## SERVICE BULLETIN

**NUMBER:** 15-321-24R

**SUBJECT:** Center Information Display Assembly / Design Change

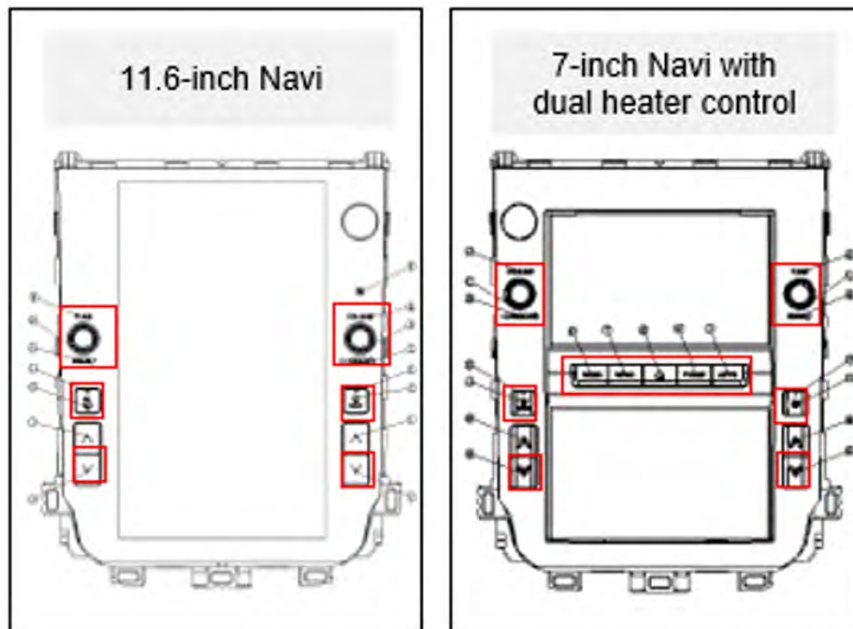
**ADJUSTMENT KNOB/BUTTON SYMPTOM DESCRIPTION:**

**NOTE:** Impreza, Crosstrek, and WRX models **ONLY**

These symptoms may be experienced in the areas indicated in **RED** outline below.

The new CIDs have been produced with an enhanced touch pad and LED material to further protect against wear caused by exposure to UV rays. If either of these symptoms are reported by a customer, refer to application and repair information outlined in this bulletin.

**BLOWER SPEED ADJUSTMENT MALFUNCTION SYMPTOM DESCRIPTION:**

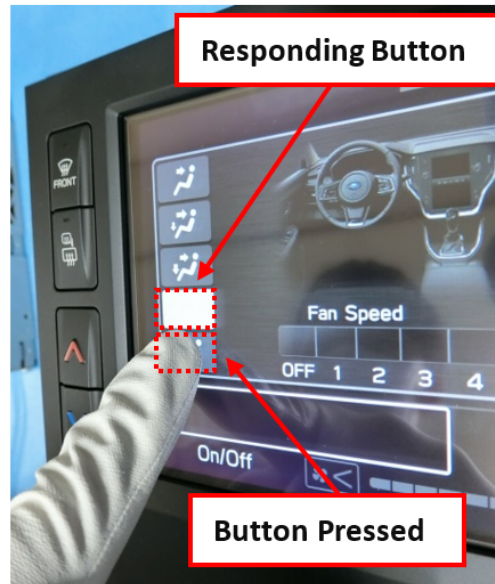
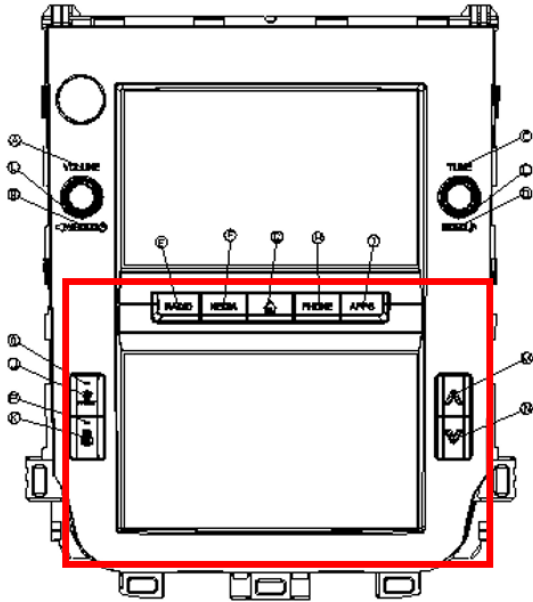
**NOTE:** This symptom **ONLY** occurs in vehicles with 7-inch touch screens.
